P30 x-series Charging Station Software Release Notes V 2.1.0

Document: V 2.1.0

35.2.3 Connector ID assignment

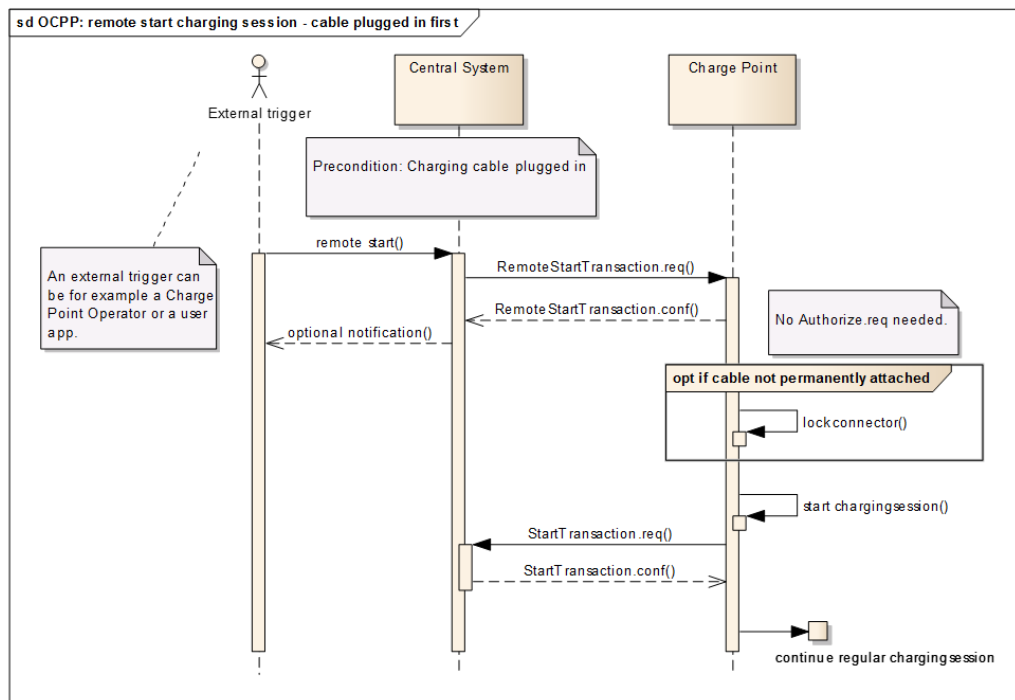
The user can assign the connector ID to a specific serial number directly via the web interface.

Remote start charging session – cable plugged in first

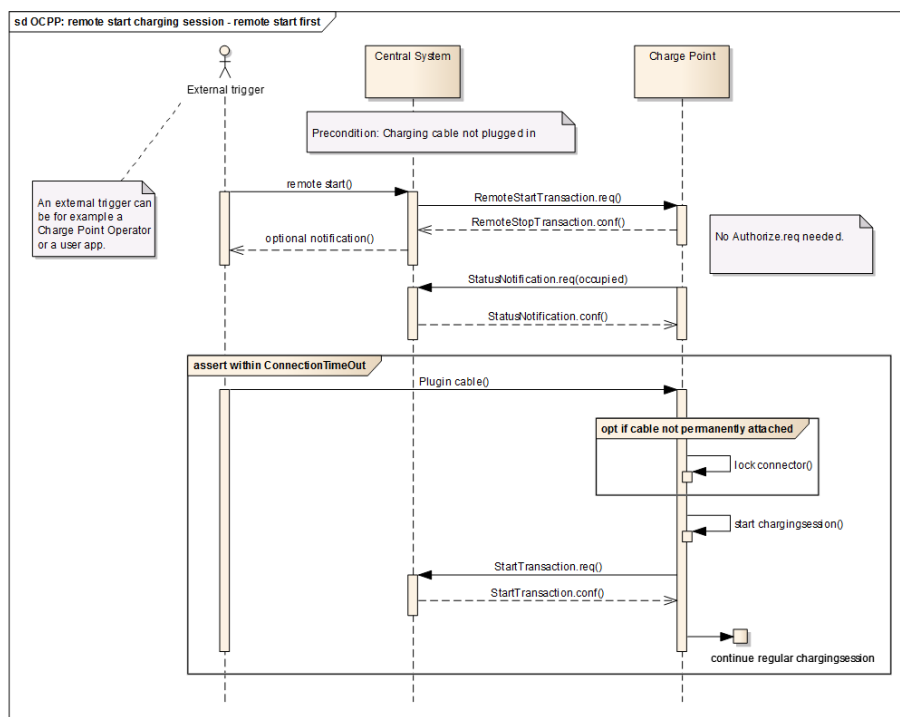
The Remote Start Transaction sequence has been modified so that the P30 replies immediately after receiving the Remote Start Transaction request.

New web page

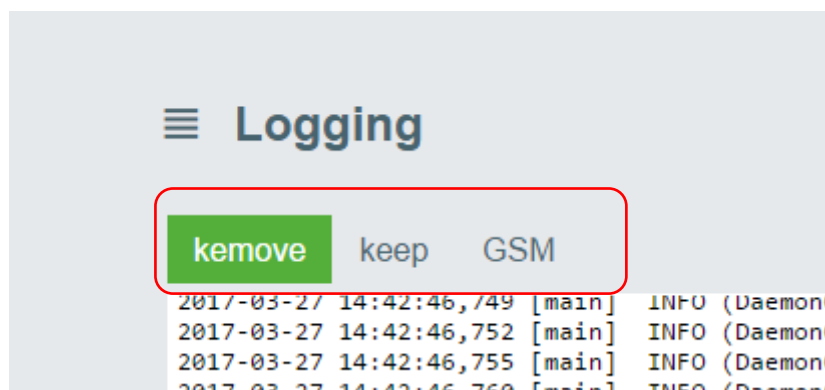
Old web page

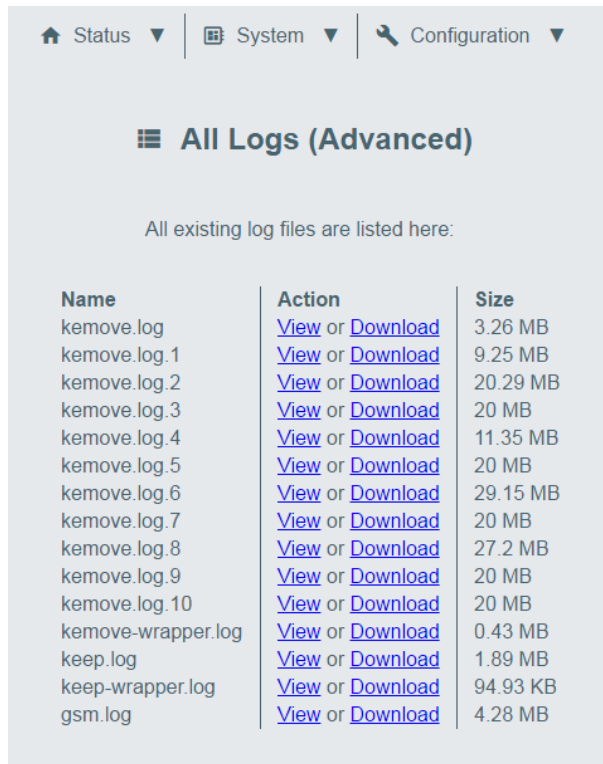
Added "All Logs" button to "Logging" tab, allows individually viewing and downloading every single log file.

Here is shown a screen shot of what the user can see if clicking on “ All Logs”.

38.3.7 WebUI – component version

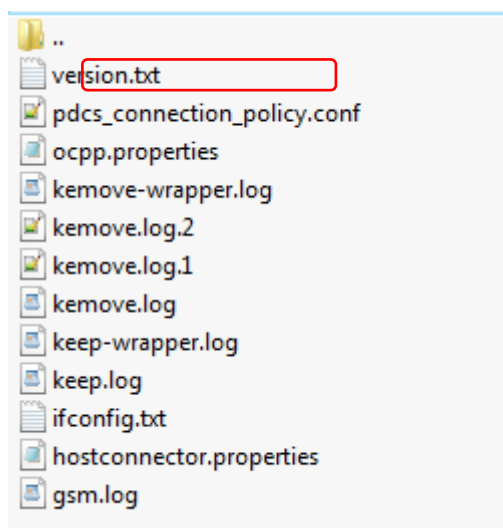
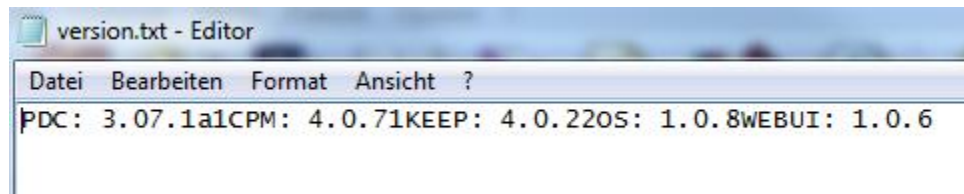
Added the text file “version.txt” in zip file accessible by clicking on "Download Latest".

In this file are enclosed the information related to the versions of the software component.
